**Traffic Engineering Assessment
Proposed Medical Centre
4-6 Brookes Street & 1 Hamilton Place, Bowen Hills**

CRG Traffic and Acoustics Pty Ltd has been engaged by QuIHN Limited to assess the traffic engineering elements of its proposal to develop a Medical Centre at Bowen Hills. This report addresses the traffic engineering matters raised in your letter dated 7 September 2010.

Figure 1: B85 Passing on 6m BCC Type B2 Driveway

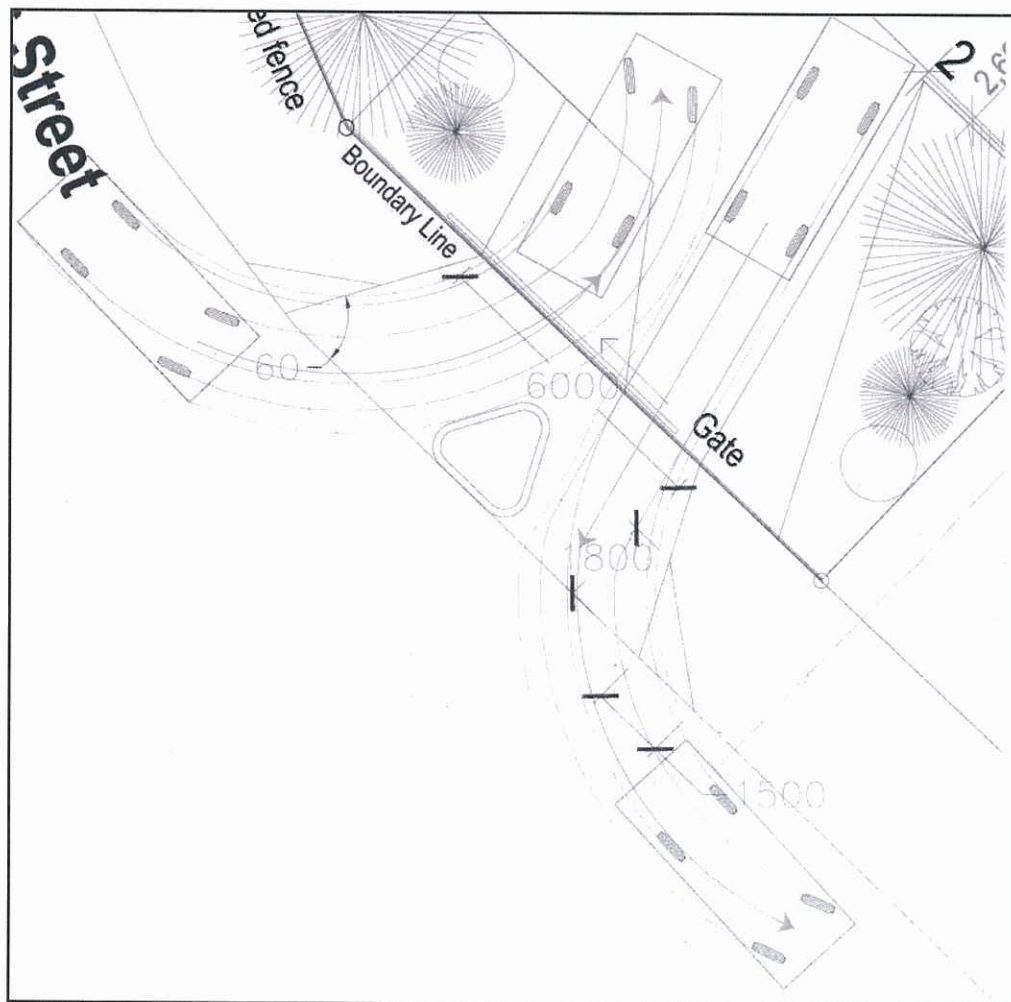
Table 9 of the TAPS policy requires a Type B2 (6m) crossover to be provided to facilitate two 85th percentile vehicles to pass one another, as shown in Figure 1. It is recommended that the proposed crossover be designed and constructed in accordance with the layout shown in Figure 1.

Figure 2: Swept path of an Ambulance

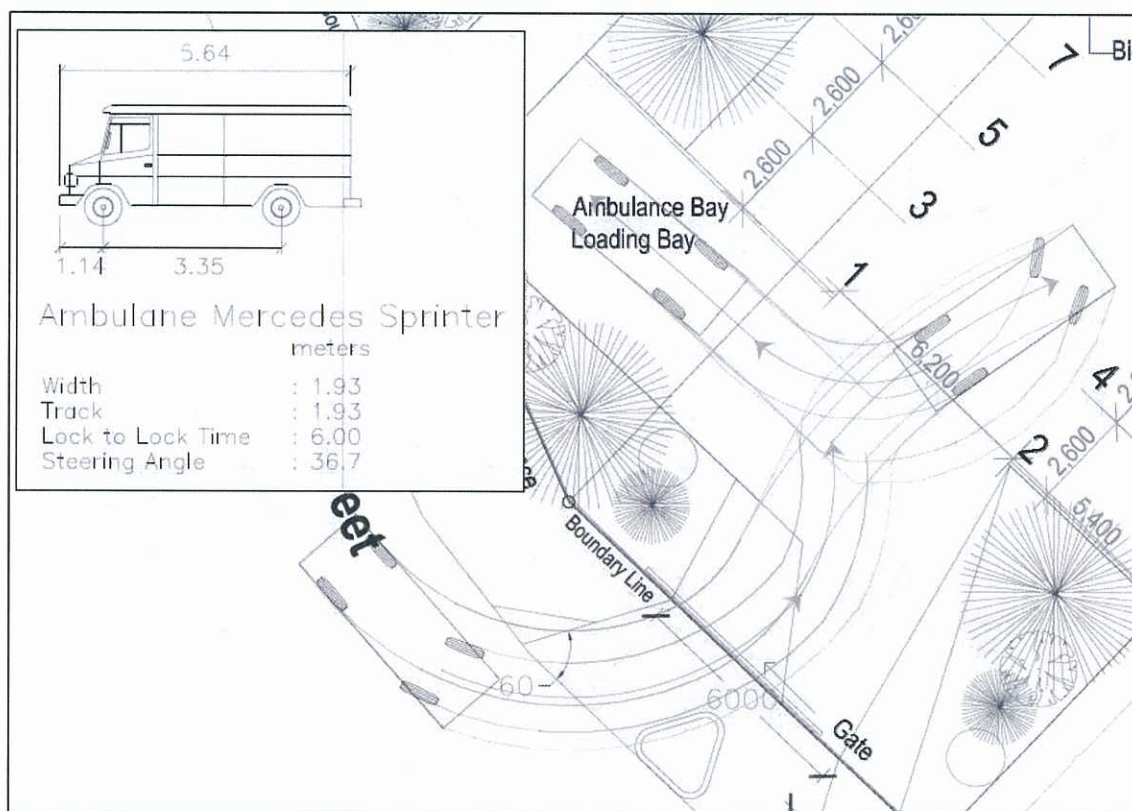
The proposed service bay allows for the manoeuvring requirements of an ambulance as shown in Figure 2. If required, delivery vehicles up to Small Rigid Vehicle (SRV) size will also be able to access the proposed service bay and exit the site in a forward direction.
